Since February 1974 injection valves are installed with double sealing edge connection:

Modified injection valve

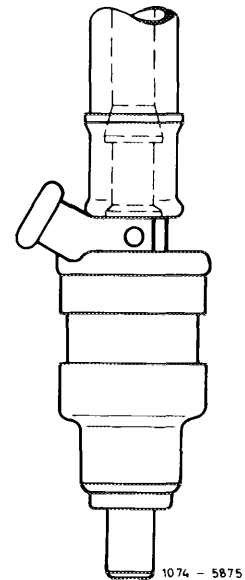
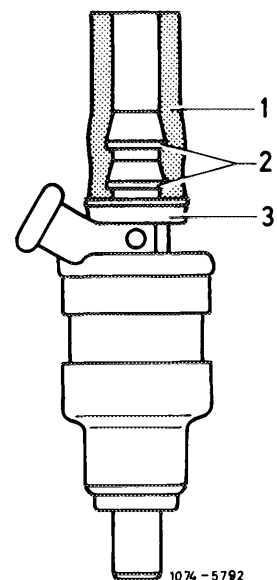
For manufacturing reasons, only the injection valve with double sealing edge connection is installed.

The fuel hose of the injection valve is attached to ring line by means of hose clip part no. 001 997 69 20.

There is no hose clip on injection valve itself.

- 1 Fuel hose
- 2 Double sealing edge connection
- 3 Hose sleeve (yellow):
height approx. 5 mm
